Addendum No. 01

Subject: Charles W. Henry Elementary School – Emergency Generator Replacement
SDP Contract No. B-060 (C) of 2017/18

This Addendum, dated September 19, 2018, shall modify and become part of the Contract Documents for the work of this project. Any items not mentioned herein, or affected by, shall be performed strictly in accordance with the original documents.

DRAWING NO.
E100

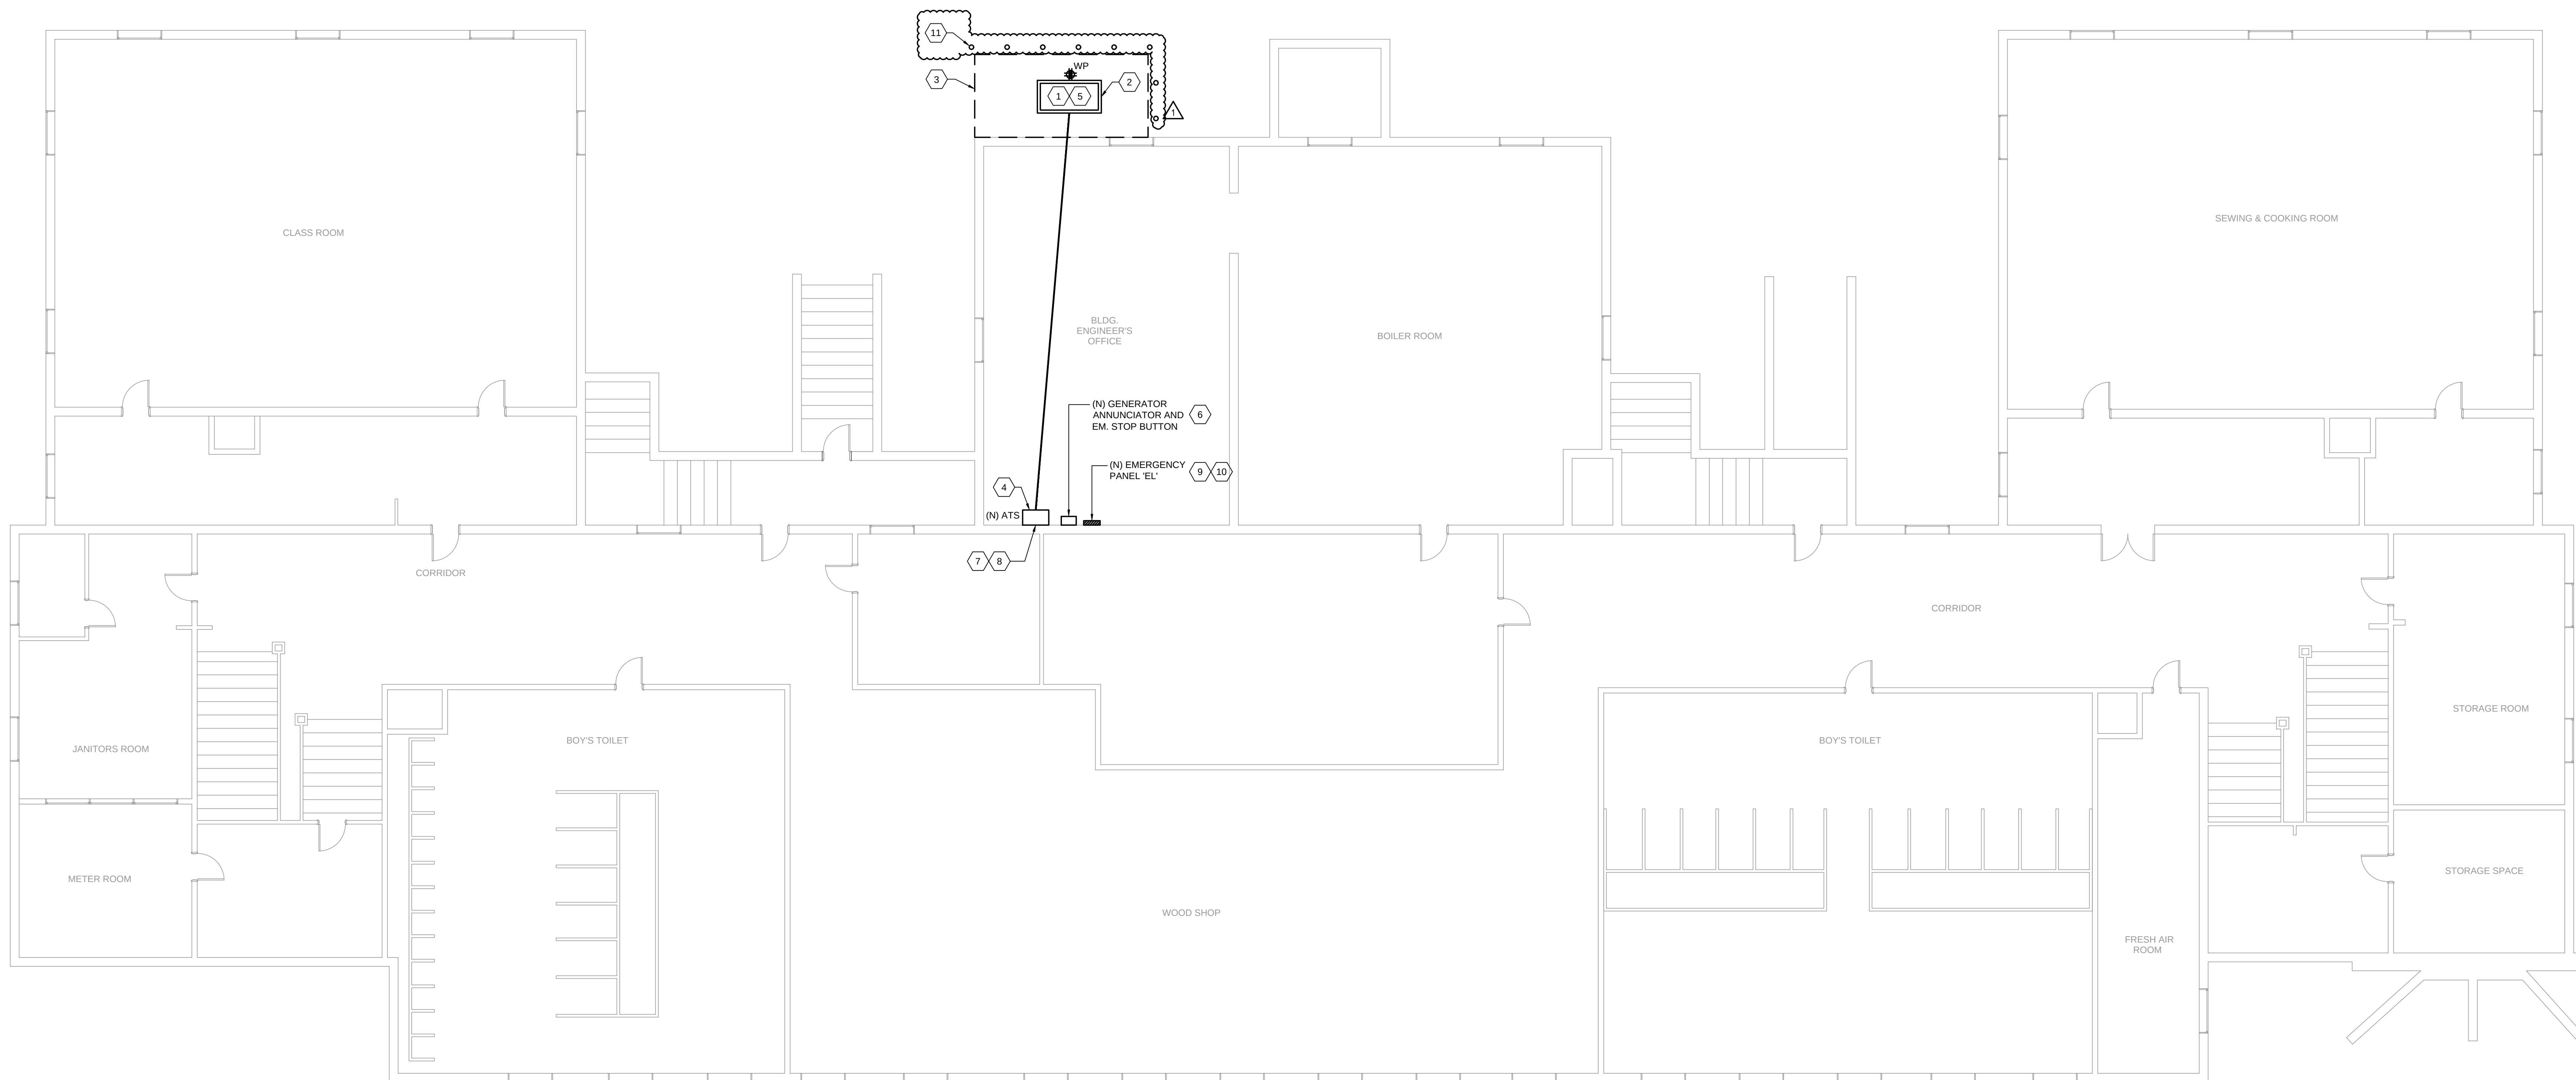
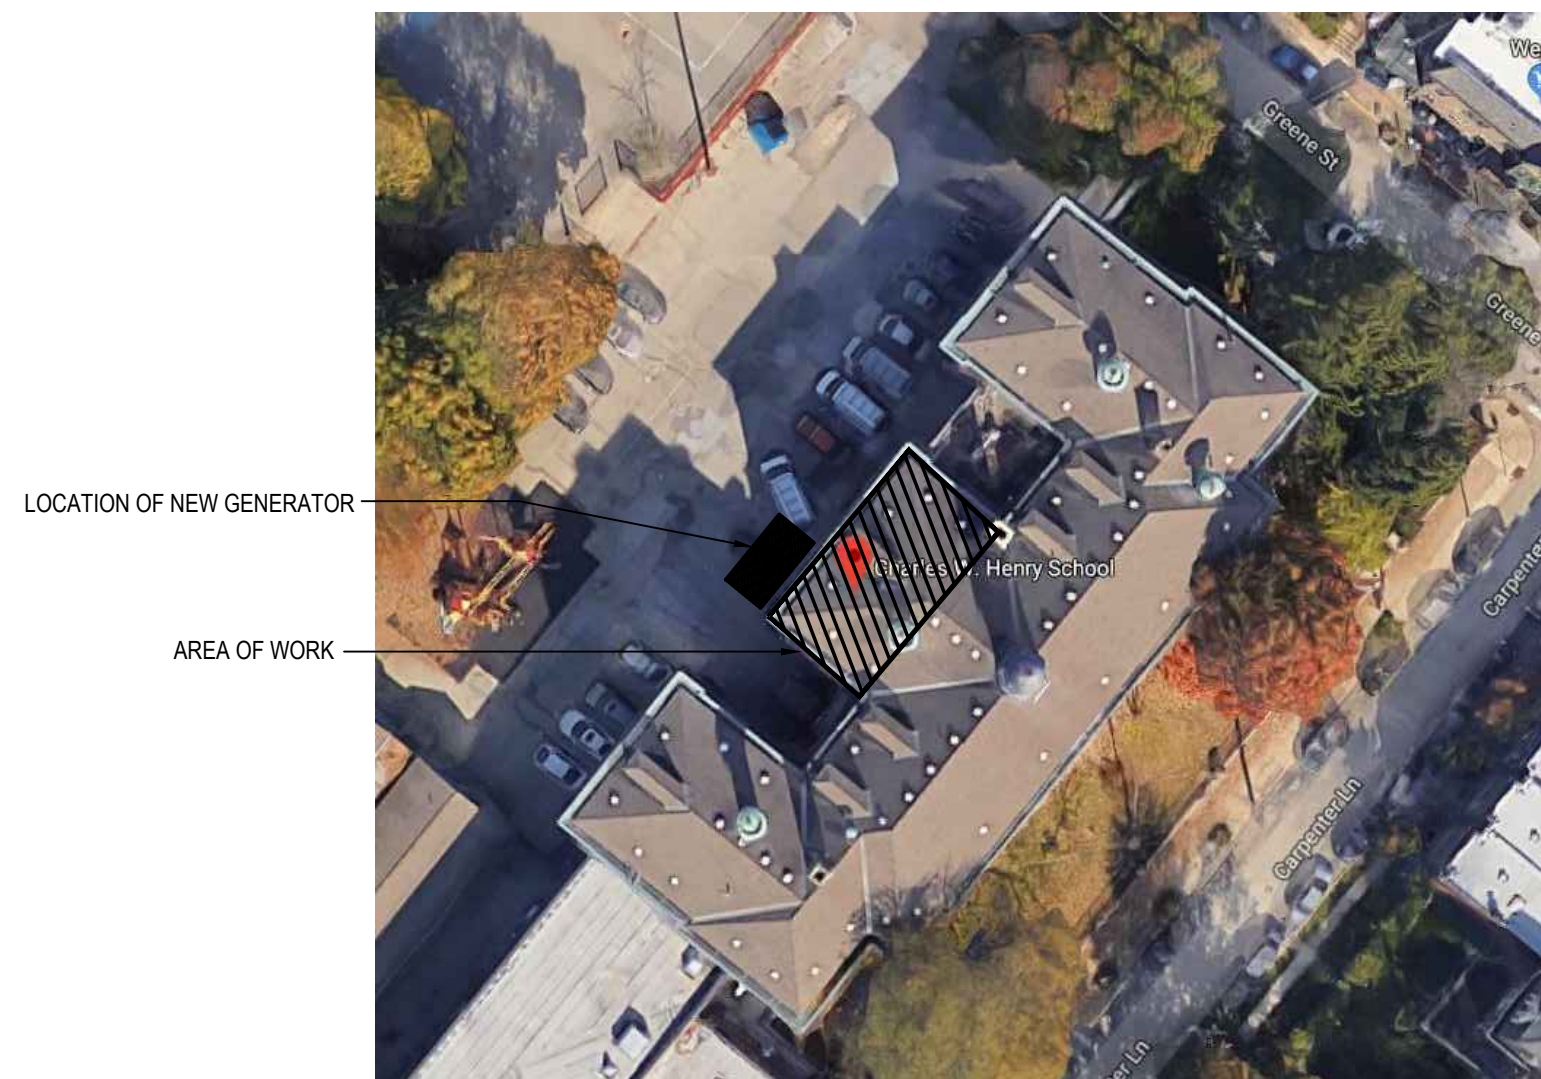
E100: Updated drawings to indicate bollards around generator fence.

11. PROVIDE BOLLARD AROUND FENCE FOR PROTECTION AGAINST VEHICULAR TRAFFIC. SEE DWG E501 FOR BOLLARD DETAIL.
